DEVIATION REQUEST AND DECISION FORM

PROJECT INFORMATION – NEW LOG ROAD DEVIATION REQUEST

Project Name : Mayberry, Colorado Springs Filing No. 1
 Schedule No.(s) : 34000-00-259, -260, -349, -350, -356, -362
 Legal Description : Mayberry, Colorado Springs Filing No. 1

(VILLAGE MAIN STREET - PHASE 1)
SCALE: 1"=5' H
1"=2.5' V

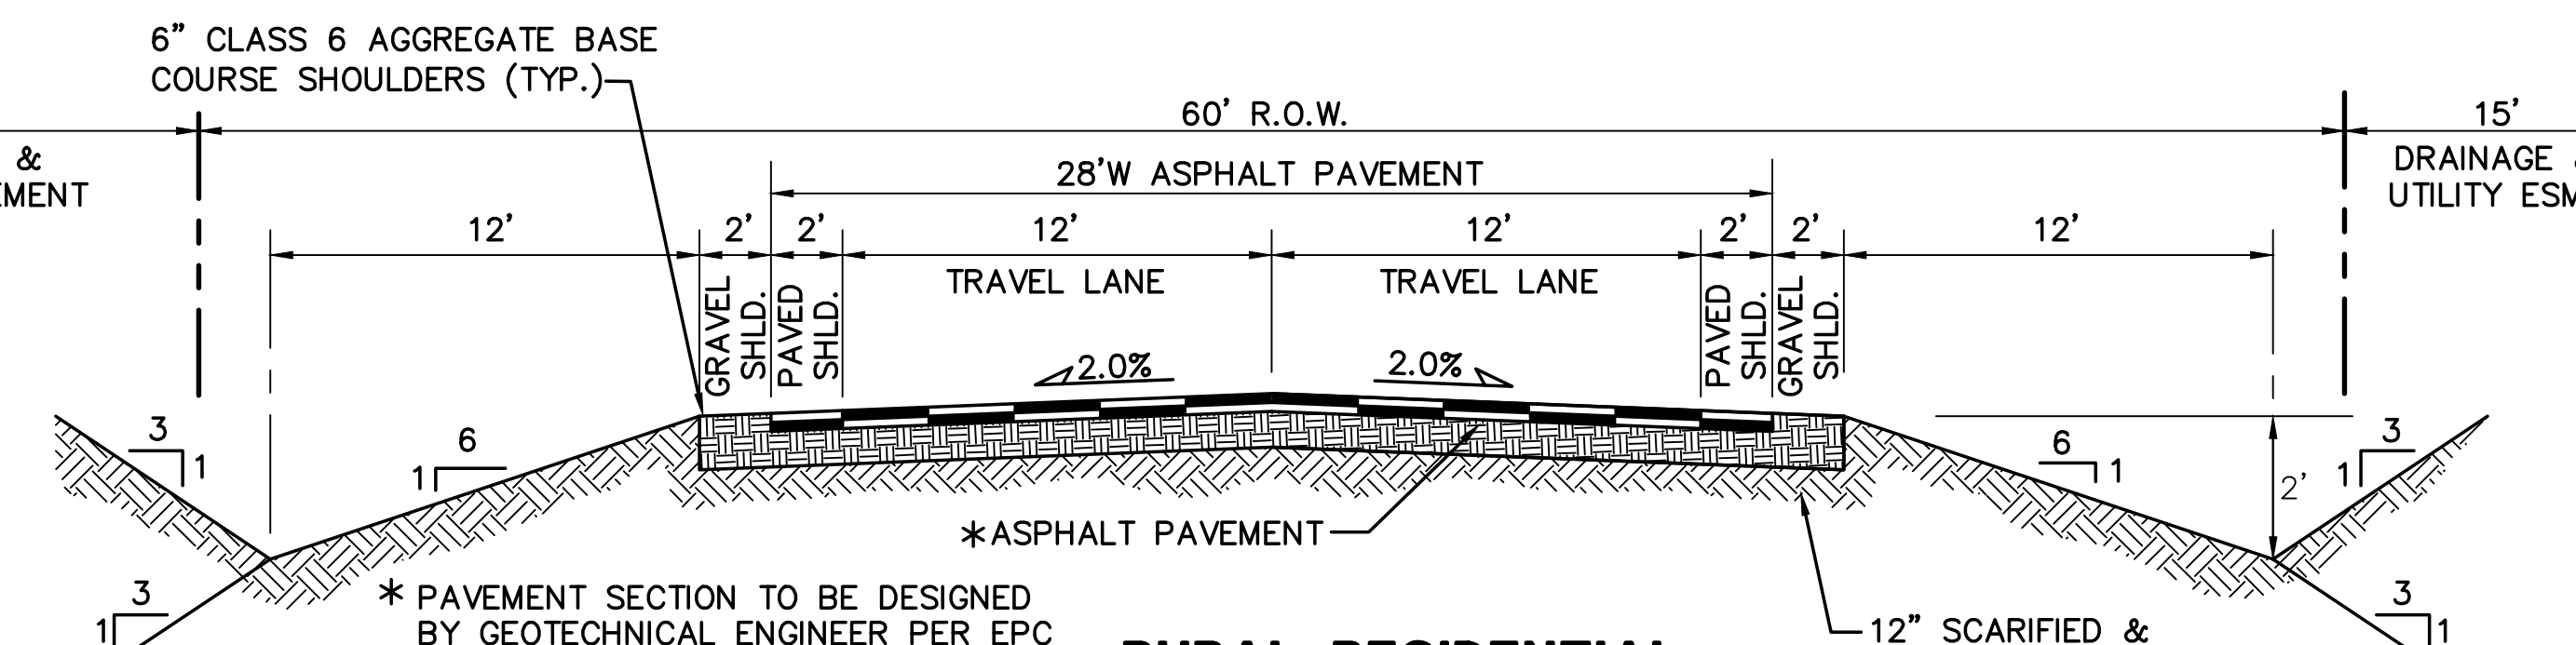
Village Main Street is ultimately classified as an Urban Non-Residential Collector through the Town Center area, and an Urban Residential Collector through the residential areas. The proposed deviations consist of modified cross-section elements including a 36-foot asphalt width for the Non-Residential Collector and a 30-foot asphalt width for the Residential Collector road segments, as well as an interim gravel secondary access road section during the initial phase of development. The proposed deviations are depicted on the Typical Road Section Drawings (Sections A-C, Sh. TY1).

The current ECM standard is a 48-foot asphalt width for an Urban Non-Residential Collector and a 36-foot asphalt width for an Urban Residential Collector. The narrower road widths are consistent with new urbanist land planning as approved in the Ellicott Town Center PUD. Minimum travel lane widths of 12 feet are provided in accordance with current ECM standards.

SHEET: **TY2**

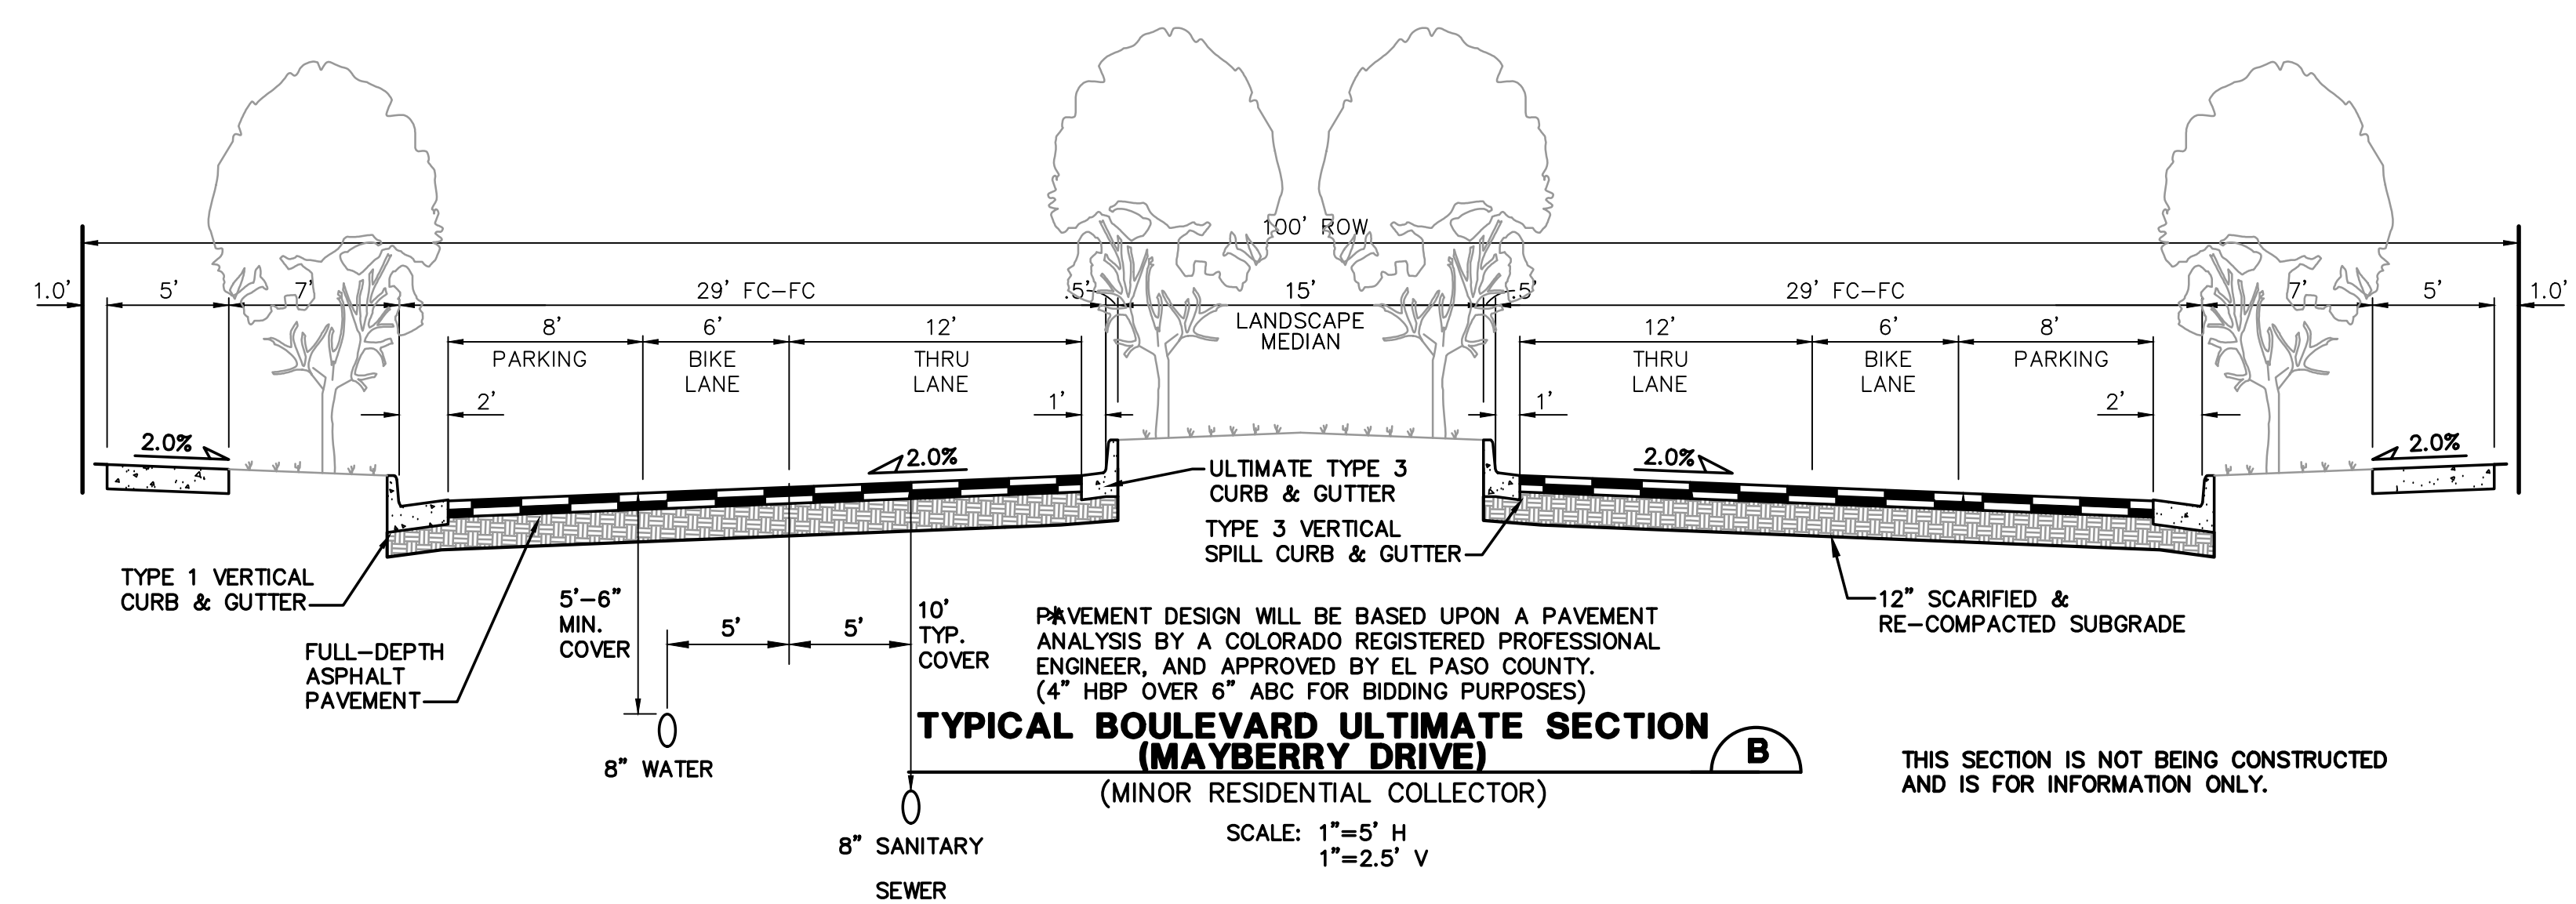
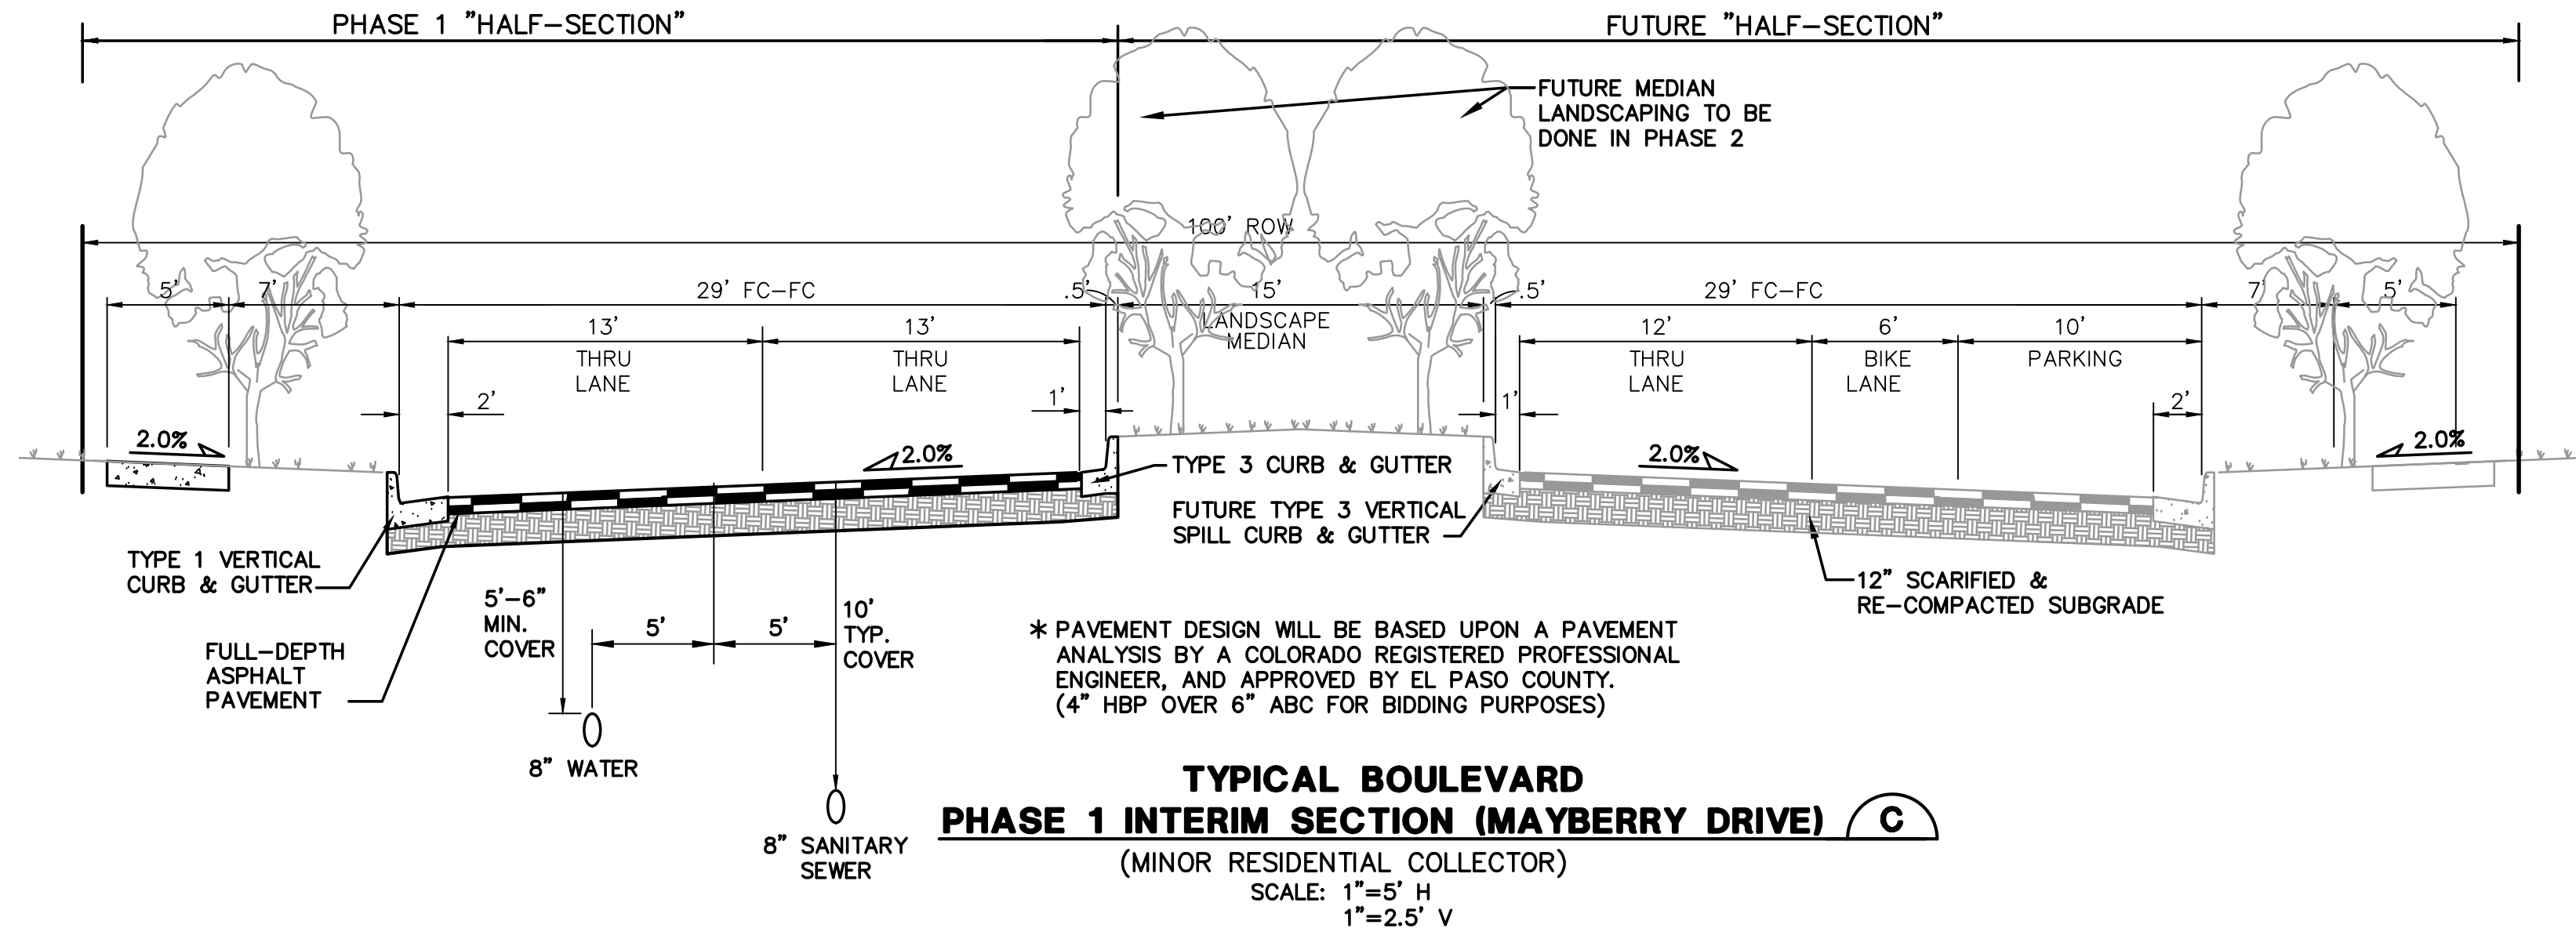
Mayberry Drive is classified as an Urban Residential Collector. The proposed deviations consist of modified cross-section elements including an ultimate divided section with landscaped median, and a Phase 1 half-section with a 29-foot asphalt width. The proposed deviations are depicted on the Typical Road Section Drawings (Sections B-C, Sh. TY2).

The current ECM standard is a 36-foot asphalt width for an Urban Residential Collector. The narrower road widths are consistent with new urbanist land planning as approved in the Ellicott Town Center PUD. Minimum travel lane widths of 12 feet are provided in accordance with current ECM standards.
